**ADDENDUM NO. 3**

**Request for Proposal Call No. RFP2024-418**  
**CONSTRUCTION OF THE FIELD HOCKEY & MULTISPORT TRAINING DOME,**  
**COMFORT STATION AT THE CASSIE CAMPBELL COMMUNITY CENTRE**

RFP 2024-418- ADDENDUM # 3

AV601

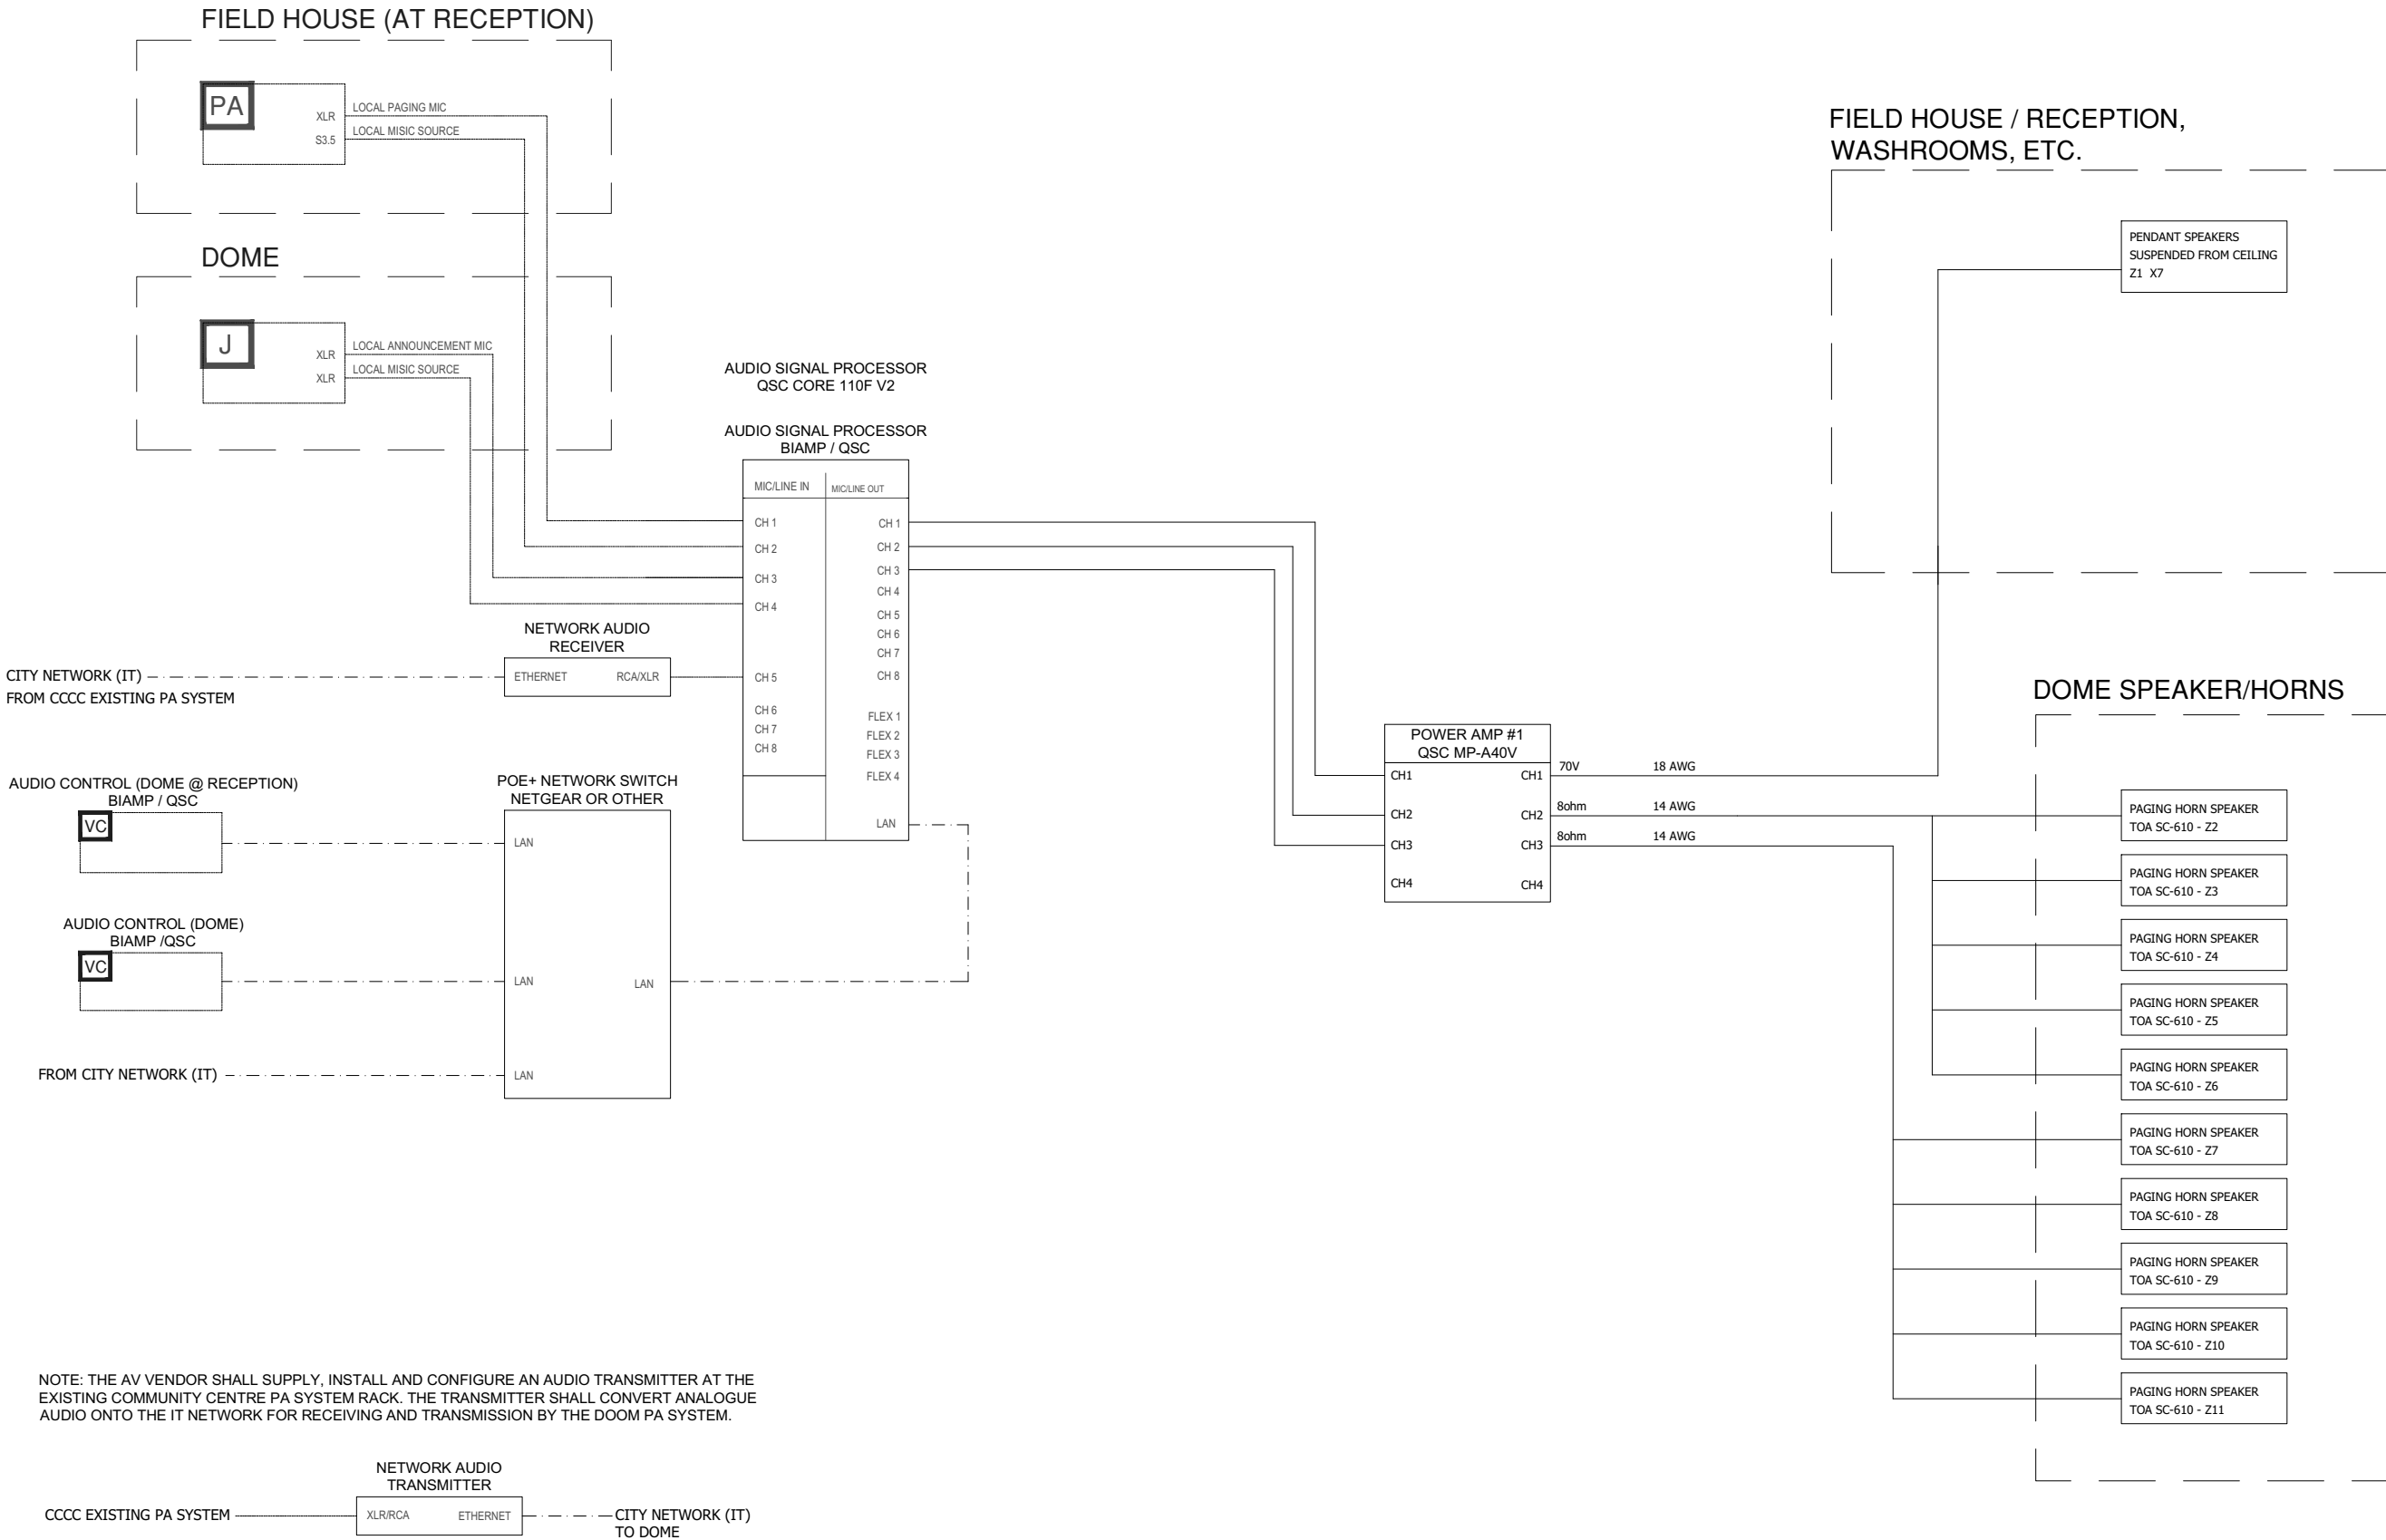
**Q1: Refer: AV601. The drawing indicates that each paging horn/speaker within the dome (playing field) to be connected to an**

**independent channel of amplification. This appears unusual approach for this space. Typically loudspeakers would be grouped into circuits dependent on wattage loading and available power amplification.**

**Since the dome area is one open space (one zone) please provide clarity on the need for each horn speaker circuited back to the power amplifier. To greatly save cost of equipment and labour will CoB accept that the Dome area be considered a single PA Zone with 2 groups of PA Horn circuits (5 horns x 2 circuits).**

A1: Review the revised drawing AV601 Rev 2 01.27.25
